Contract #: 04-0120F4Cty: SF/ALA Rte: 80 PM: 13.2/13.9File #: 69.25B**QUALITY ASSURANCE -- NON-CONFORMANCE REPORT****Location:** Changxing Island, Shanghai, P.R. China**Report No:** NCR-000759**Prime Contractor:** American Bridge/Fluor Enterprises, a JV**Date:** 09-Jun-2010**Submitting Contractor:** Zhenhua Port Machinery Company, Ltd (ZPMC), Changxing Island**NCR #:** ZPMC-0721**Type of problem:**

**Reference Description:** QA found an UT Indication after the contractor's had tested and accepted a weld for Suspender Bracket SB014-PP52 (Lift 7E)

**Subject:** NCR No. ZPMC-0721

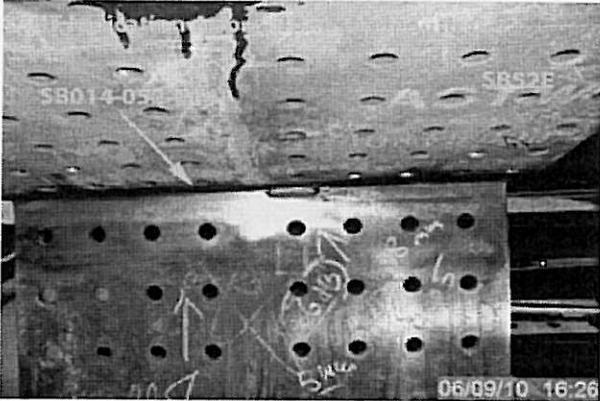
During the Quality Assurance (QA) Ultrasonic Testing (UT) review of welds located on Orthotropic Box Girder (OBG) Suspender Bracket SB014-PP52, this QA Inspector discovered the following issues:

- One (1) Class A longitudinal indication measuring approximately 15mm in length.
- The indication dB rating is +6.
- Material thickness is 22mm.
- The depth of the indication is approximately 8.5mm.
- The weld is identified as SB014-052-004.
- The weld is Complete Joint Penetration (CJP) "T" joint joining the bracket top to side.
- The indication is clearly marked near the weld.
- The Y distance for this indication is 375mm measured from the west end of the bracket.
- Suspender Bracket SB014-PP52 is located in fabrication Bay 19.

The Notice of Witness Inspection (NWIT) No. is 005939. The indication is located within the area previously tested and accepted by ZPMC Quality Control (QC) personnel. As per the contract documents, ZPMC's QC personnel are required to perform hundred (100%) percent UT inspection of this weld.

Repair said indication and perform NDT required to verify weld quality.

Contractor supplied post repair NDT documentation verifying weld conforms with Contract weld quality requirements.
